Western Sub Regional RTEP: AEP Supplemental Projects

July 18, 2025

Changes to the Existing Supplemental Projects

AEP Transmission Zone: Supplemental S2167 Scope Change

Supplemental Project ID: S2167

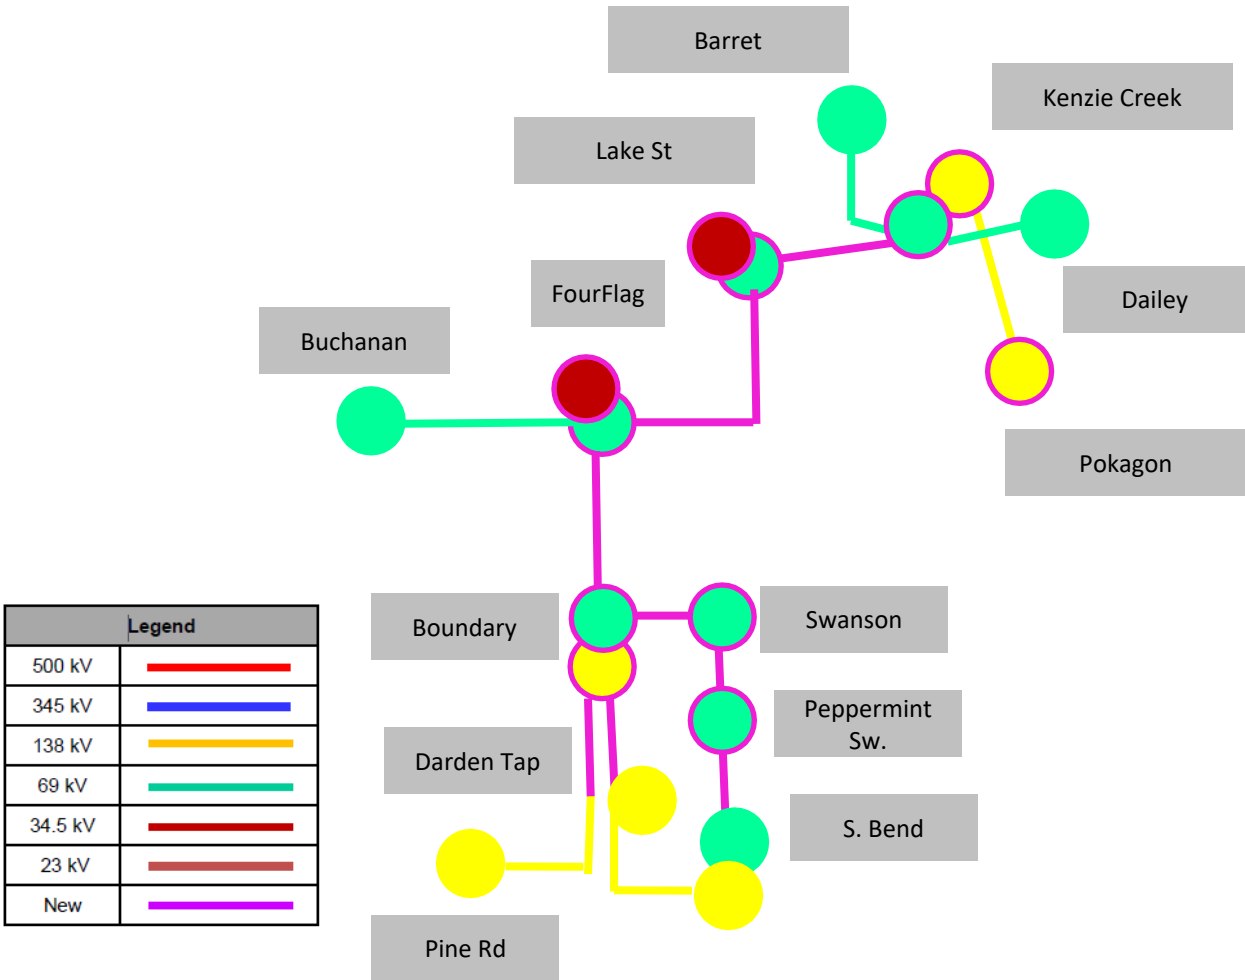
Rebuild Swanson in the clear. Cost: ~~\$2.1M~~ **\$2.6M**

Estimated Cost: ~~\$101.3M~~ **\$125.8M**

Projected In-Service: ~~06/01/2022~~ **3/13/2026**
